RE: Oil & Gas RICE GP02 General Permit Approval for Package # 511183

Attachment F

Air Impact Analysis

Plant/Site Name: Crusoe Energy Systems, Inc. Ray Ranch North Pad

SOURCE LOCATIONS (AERIAL)

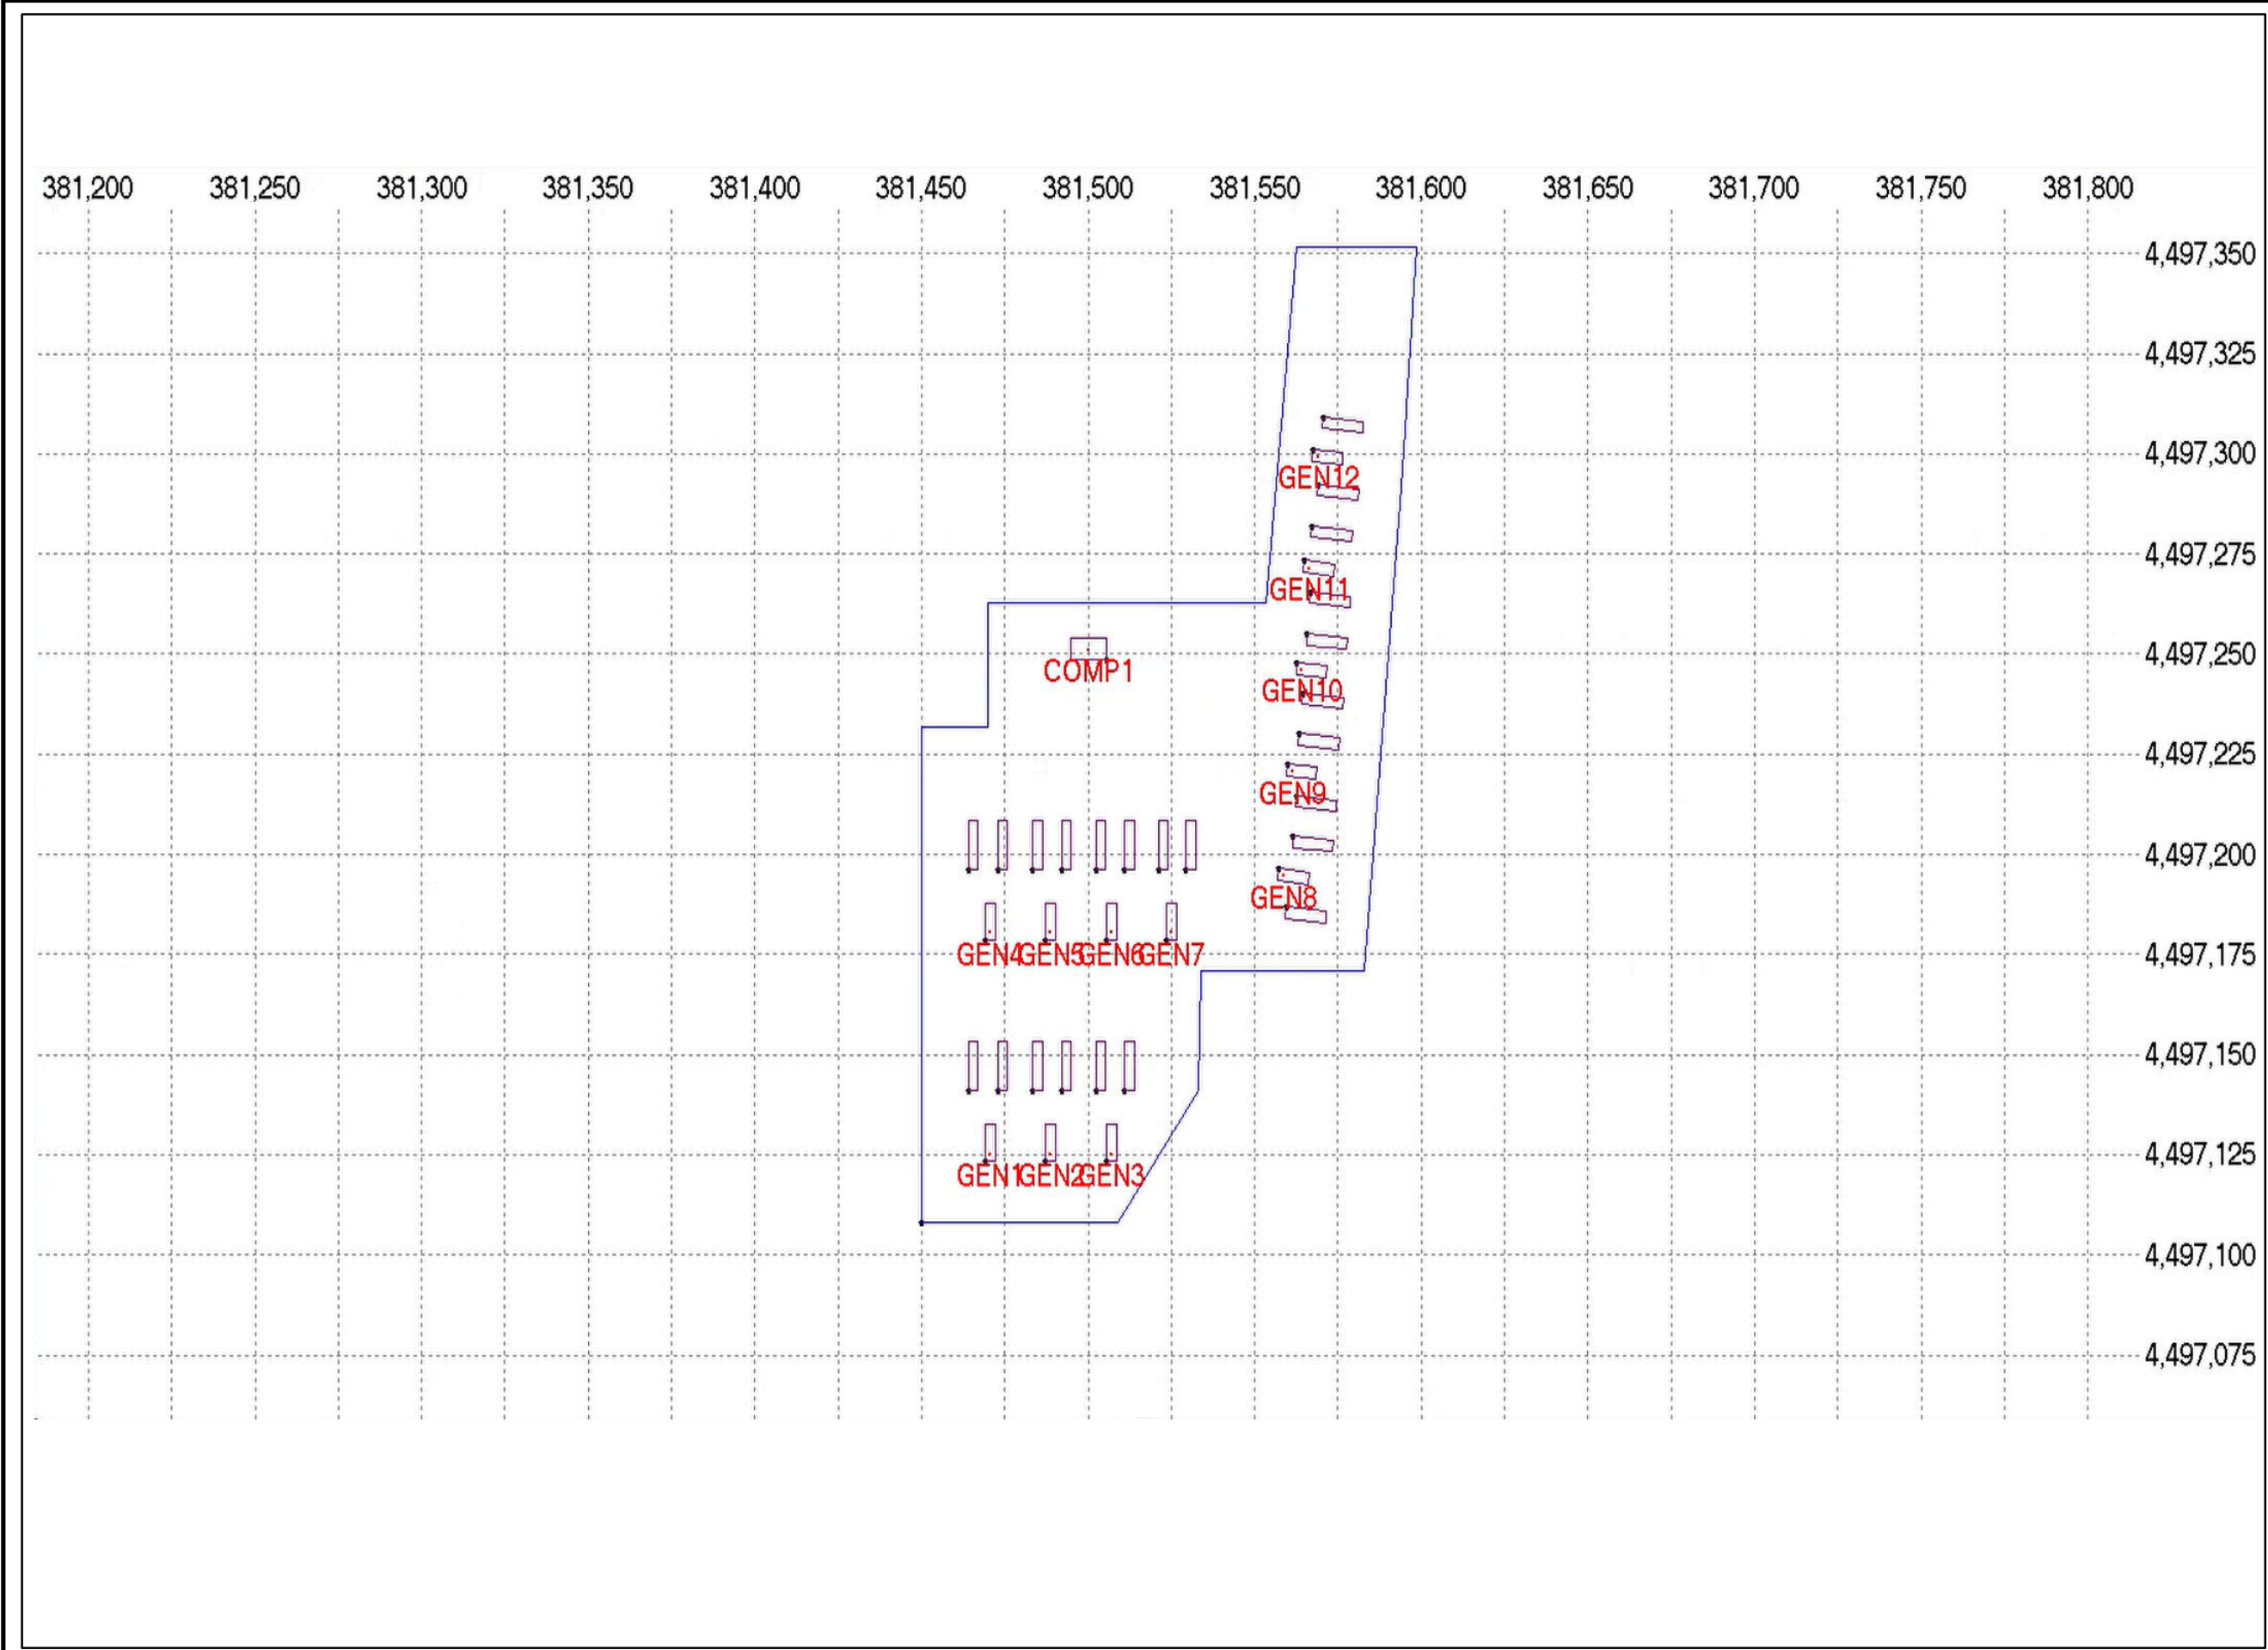
Note: After completion of this review it was brought to our attention by the permit engineer that this site is co-located and therefore the co-located sources should have been included in the cumulative assessments. DMU did modeling runs to confirm that the inclusion of the Fulcrum Energy - Ray Ranch North co-located sources did not significantly impact the modeled concentrations and therefore did not require the applicant to resubmit modeling.

Note added 11/21/25
